## **Appendix I – Modifications of Standards at SGH**

**From:** [Seth Timmerman](#)  
**To:** [Snyder, Chris](#); [Strack, Paul](#); [Muia, Maria](#); [Tom Franzen](#)  
**Subject:** Fwd: SGH Proposed MOS for Runway 15/33 OFA  
**Date:** Friday, January 31, 2020 3:41:57 PM

**From:** **Delaney, Katherine S (FAA)** <[Katherine.S.Delaney@faa.gov](mailto:Katherine.S.Delaney@faa.gov)>  
**Date:** Fri, Jan 31, 2020 at 3:38 PM  
**Subject:** SGH Proposed MOS for Runway 15/33 OFA  
**To:** Seth Timmerman <[stimmerman@springfieldohio.gov](mailto:stimmerman@springfieldohio.gov)>  
**Cc:** Erskine, Alex (FAA) <[Alex.Erskine@faa.gov](mailto:Alex.Erskine@faa.gov)>

**CROSSWIND RUNWAY 15-33 ALTERNATIVES  
 ALT. C-5 REQUEST FOR MODIFICATION TO STANDARDS  
 SPRINGFIELD-BECKLEY AIRPORT  
 SPRINGFIELD, OHIO**

**CROSSWIND RUNWAY 15-33 ALTERNATIVES**  
ALT. C-9 DECLARED DISTANCE TO FIX RW 33 ROFA AND RPZ

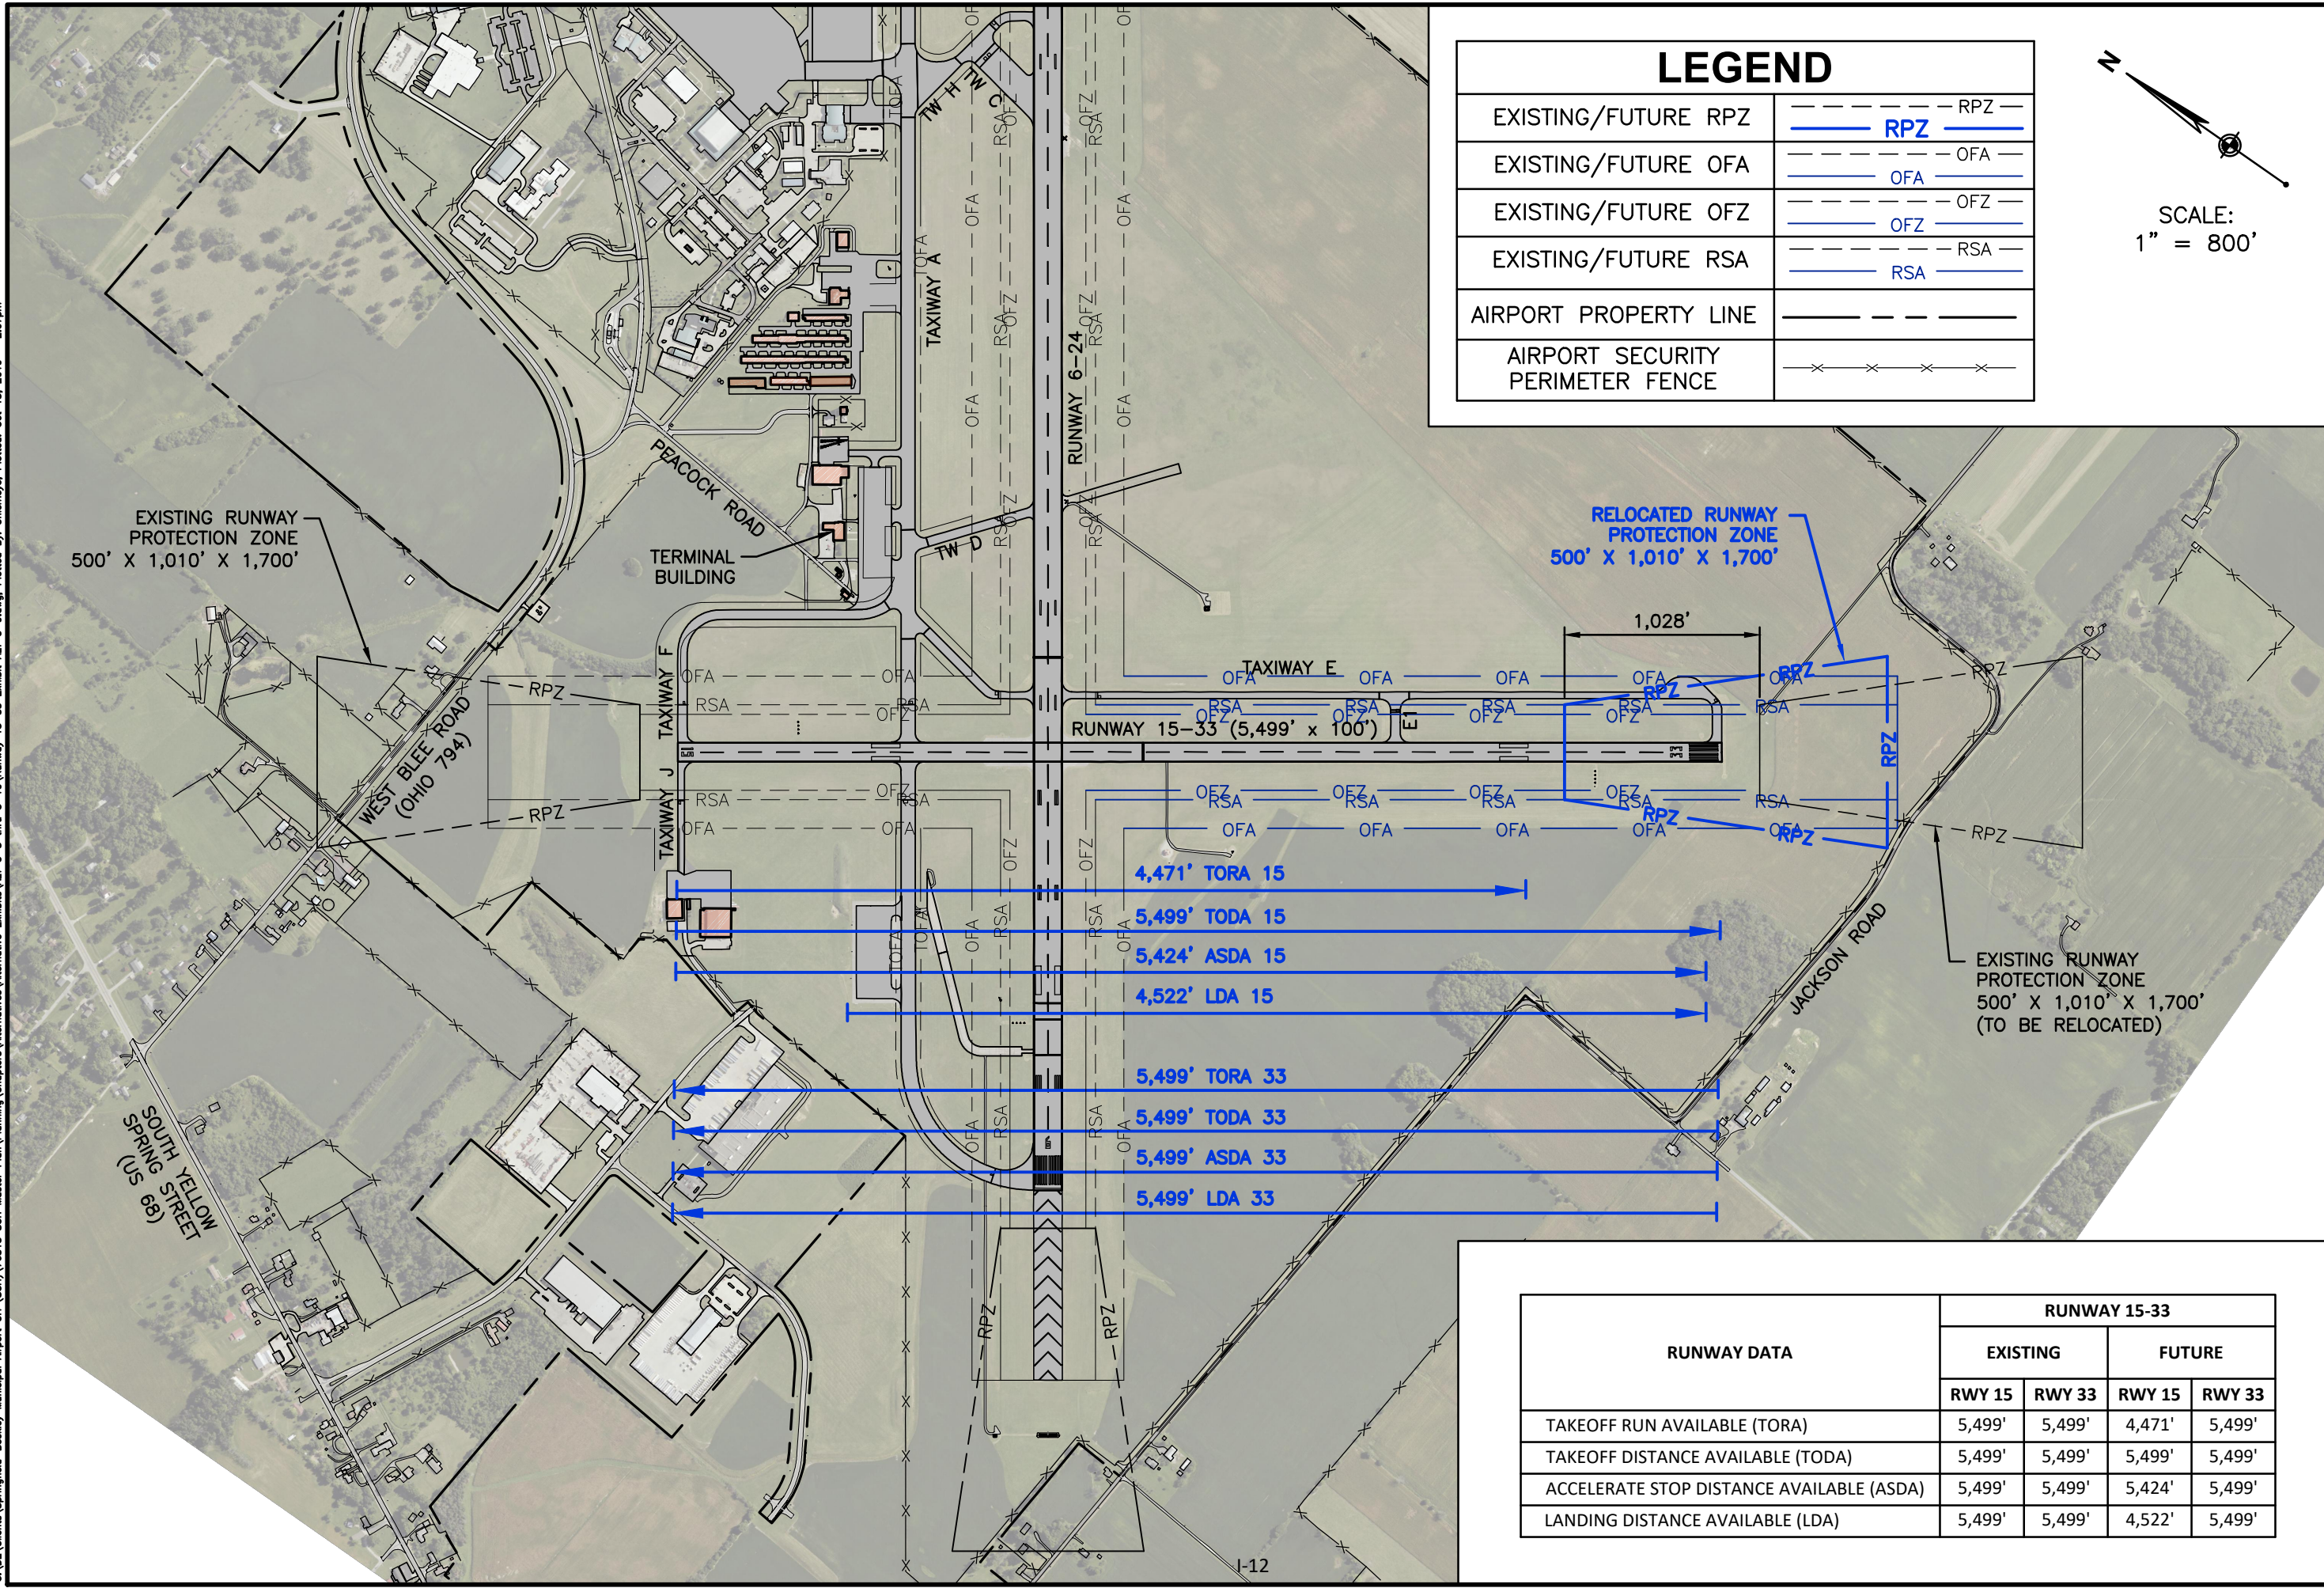
Alternative C-9: Declared Distance to fix Runway 33 ROFA and RPZ (see *attachment Runway 15-33 Exhibit Alt C-9.pdf*) This reduces the TORA, ASDA and LDA for Runway 15 to provide for a clear ROFA and a compatible RPZ for Runway 33. The RPZ for Runway 15 remains incompatible as it is today.

**CROSSWIND RUNWAY 15-33 ALTERNATIVES**  
ALT. C-10 DECLARED DISTANCE TO FIX RW 33 ROFA AND RPZ AND RW 15 RPZ  
**SPRINGFIELD-BECKLEY AIRPORT**  
**SPRINGFIELD, OHIO**

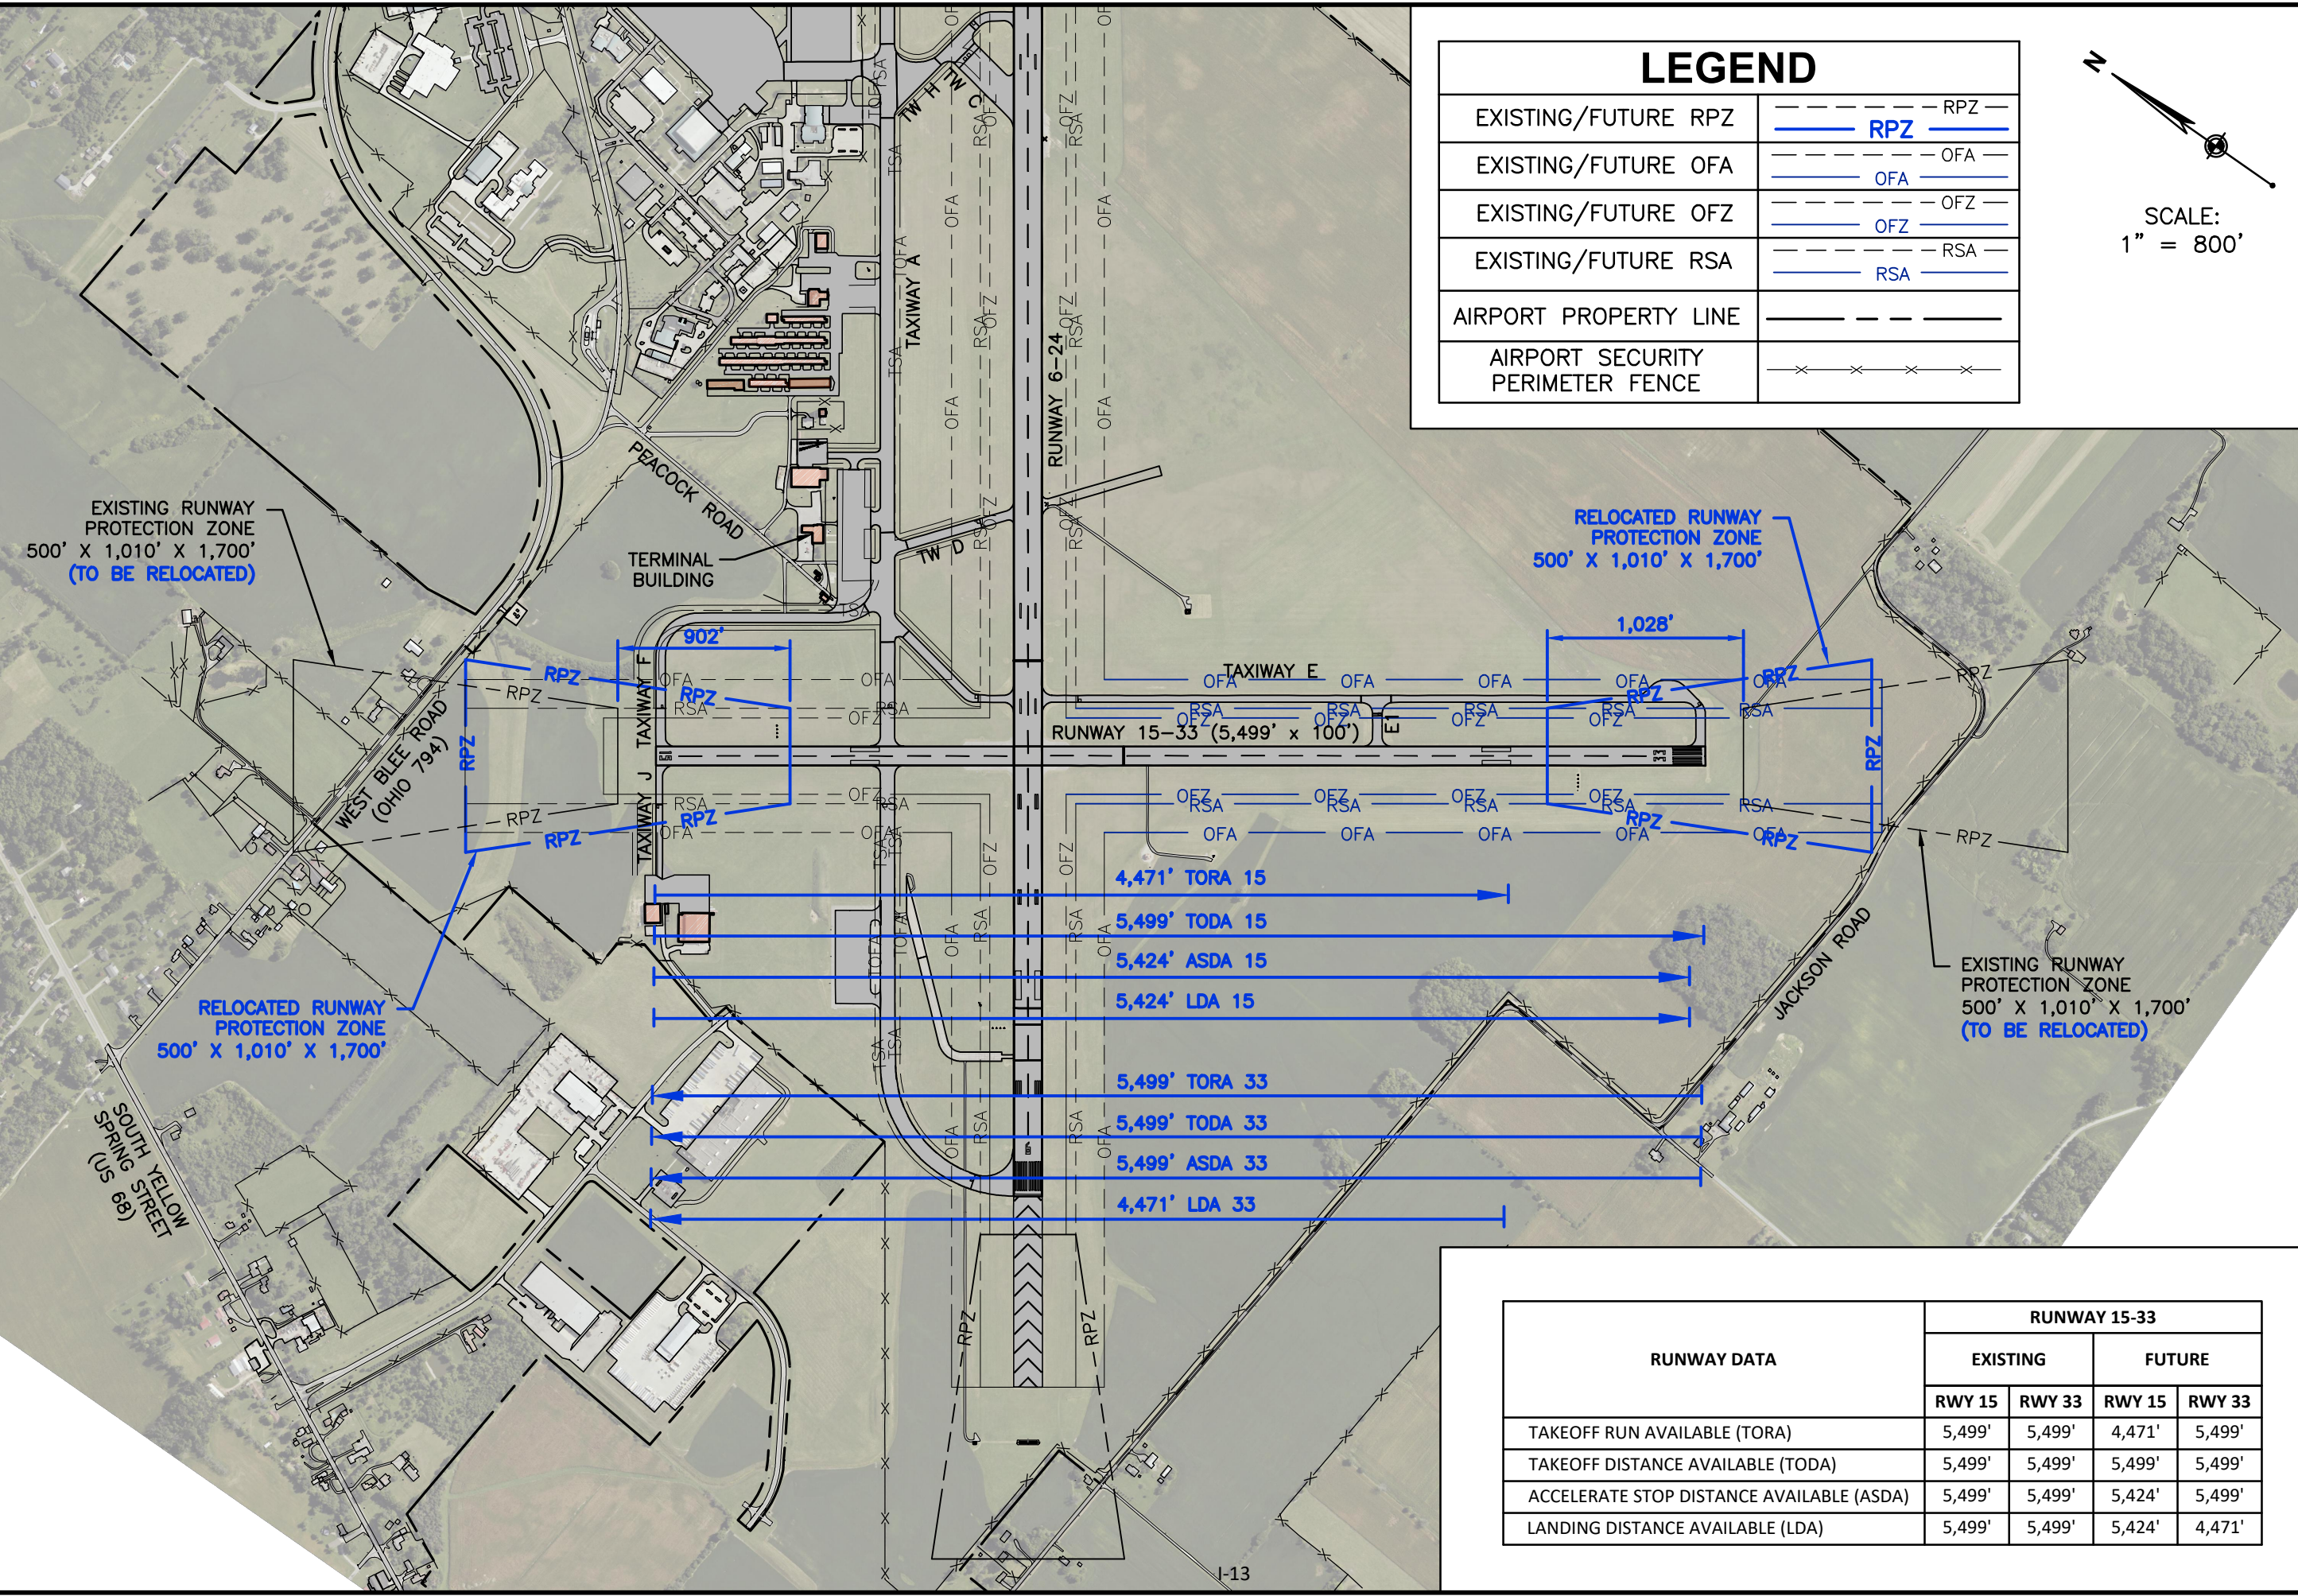
Alternative C-10: Declared Distance to fix Runway 33 ROFA and RPZ and Runway 15 RPZ (see *attachment Runway 15-33 Exhibit Alt C-10.pdf*) This reduces the TORA, ASDA and LDA for Runway 15 to provide for a clear ROFA and a compatible RPZ for Runway 33. It also reduces the LDA for Runway 15 to provide for a compatible RPZ for Runway 15.
